737

Service Bulletin

Number: 737-28-1303
Original Issue: April 26, 2012
Revision 1: January 22, 2015
ATA System: 2800

SUBJECT: FUEL - General - Left Environmental Control Systems Bay Wire Clamp - Inspection and Replacement

FIGURE 4: LEFT SIDE - ENVIRONMENTAL CONTROL SYSTEMS (ECS) BAY - WIRE CLAMP - REPLACEMENT (SHEET 1 OF 2)

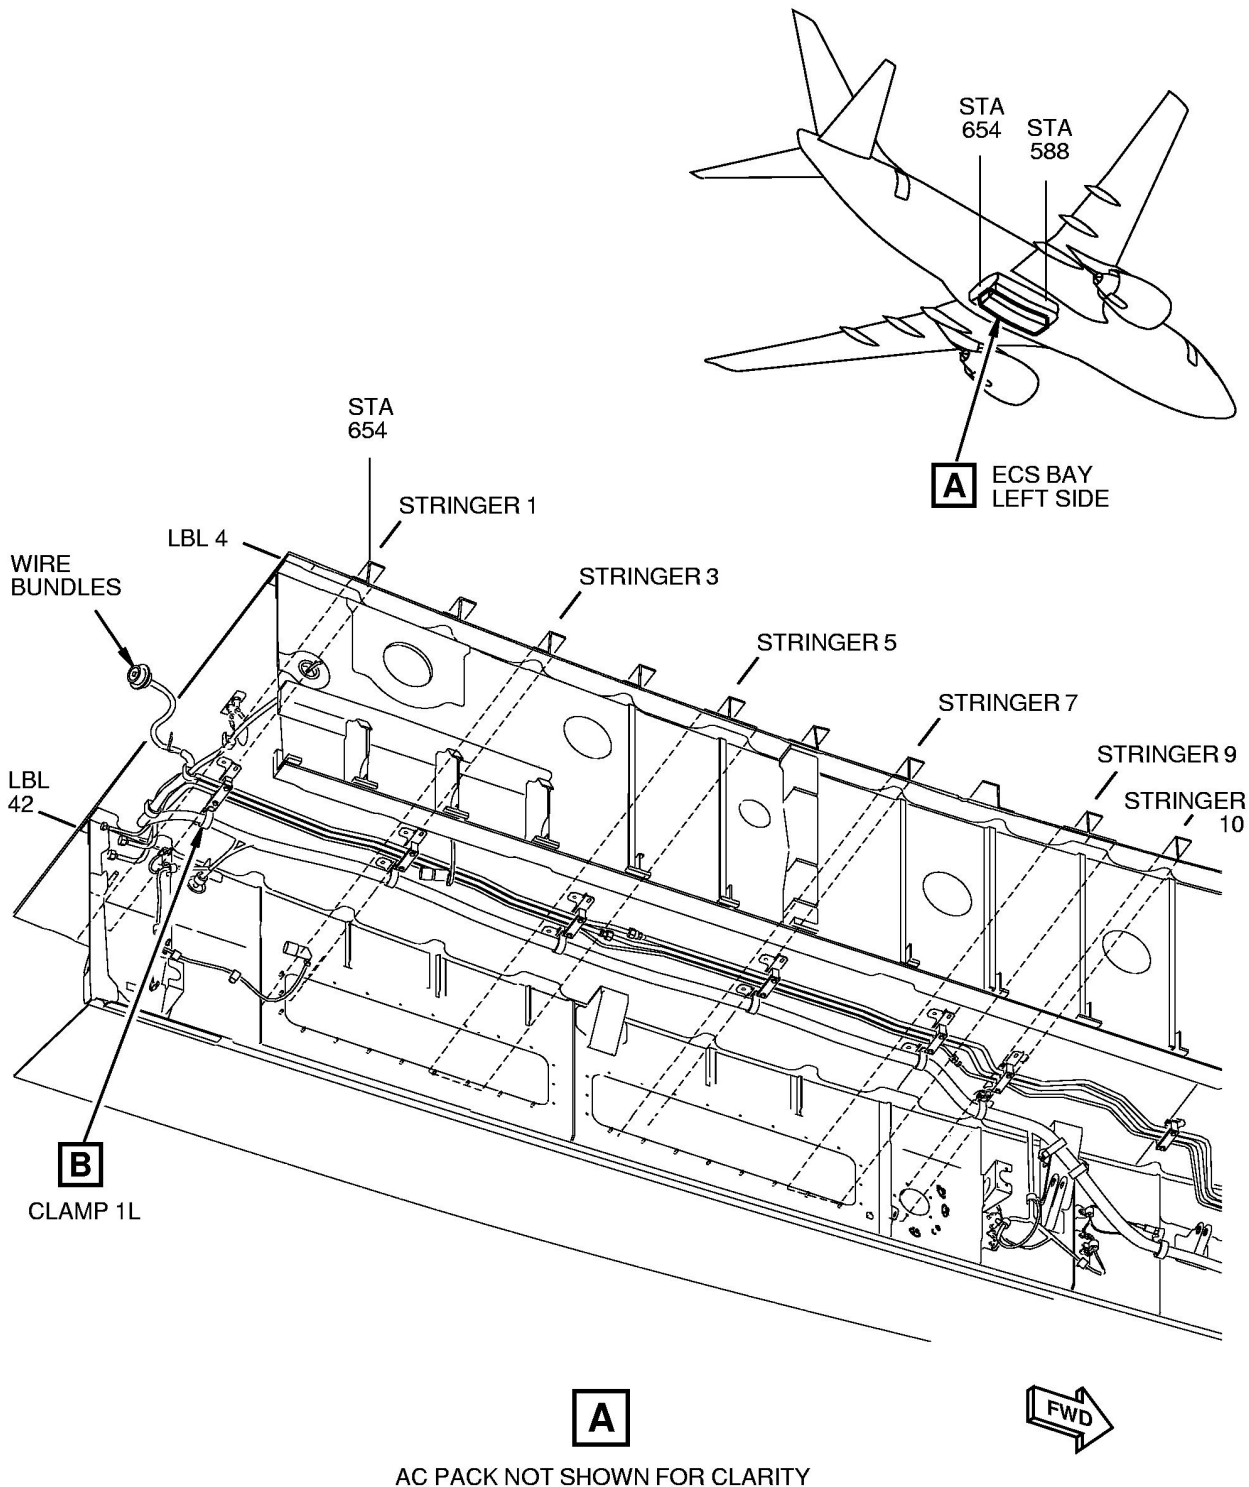
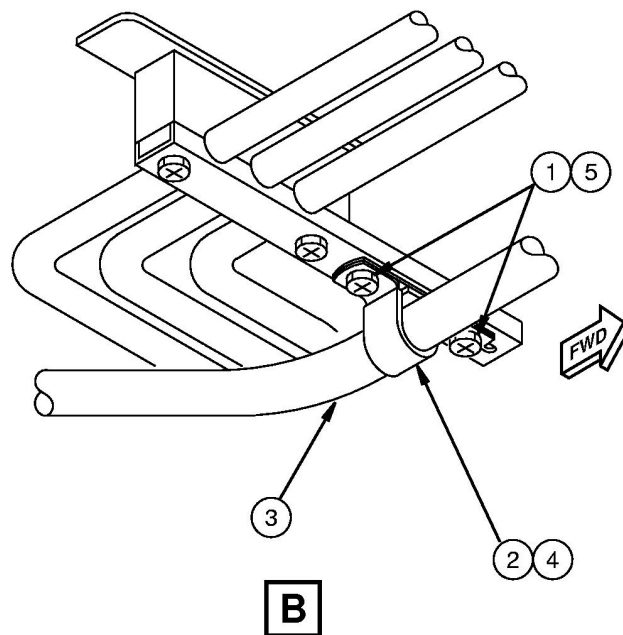
Step	Task	Name	Identification	Qty	More Data
1	Remove / Keep	Fastener	-	2	
2	Remove	Clamp	-	1	
3	Inspect	Wire Bundle	-	-	(a)
4	Install (New)	Clamp	TA0930034-10 (TA0930034-10P or TA0930034-11 or TA0930034-12P optional)	1	(b)
5	Install (Kept)	Fastener	-	2	(b)
(a) Do a Detailed Inspection of the wire bundle for damage (chafing) at the specified clamp location. If damaged wires are found, repair damaged wires. Refer to SWPM 20-10-13 as an accepted procedure for damage conditions and repair instructions.					
(b) Refer to SWPM 20-10-12 as an accepted procedure.
